**SUBJECT:** Final Environmental Assessment for the Use of Department of Energy-Owned High-Assay Low-Enriched Uranium Stored at Idaho National Laboratory (CLN190431)

# **Environmental Assessment for Use of DOE-Owned High-Assay Low-Enriched Uranium Stored at Idaho National Laboratory**

## **APPENDIX A – Comment Responses**

**Figure 2.** Actual and hypothetical public *receptor* locations for the air pathway analysis showing distance and direction from MFC and INTEC. Regulatory dose limits do not apply to the nearest boundary locations.

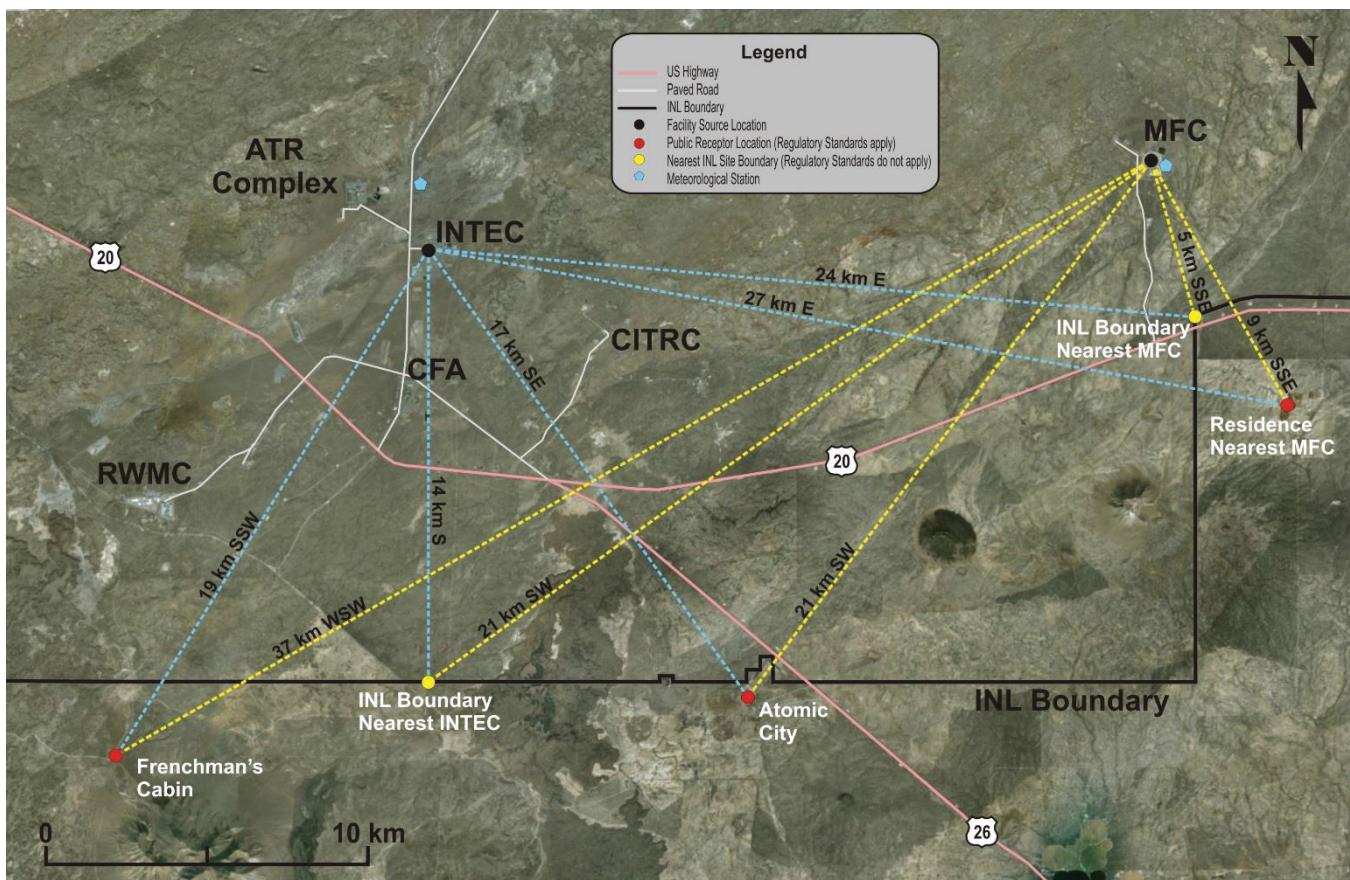
While the Tribes are concerned with any additional radiological emissions at INL, we are especially concerned with how radiological emissions will impact Tribal sacred sites at INL and Tribal members who may use those areas. In Figure 2 of the Draft EA, the DOE provided a map of actual and hypothetical public receptor sites. And Table 2 provides the effective yearly doses at various sites. But the Draft EA mentions neither what potential effective dose (ED) would occur at Tribal sacred sites like Middle Butte, nor the safety limit for Tribal members who go to Middle Butte for ceremonial activities. This should be included in the EA.

We might expect that the Total ED for Middle Butte would be slightly less than it is for the "Residence Nearest MFC." At this site, Alternative 1 would create less total ED—and presumably less ED at Middle Butte. Therefore, if those assumptions are correct, then Alternative 1b would yield less Total ED to the Middle Butte area. All else being equal, the Tribes would prefer the alternative that creates the least amount of radiological exposure to Middle Butte and other Tribal sacred areas.
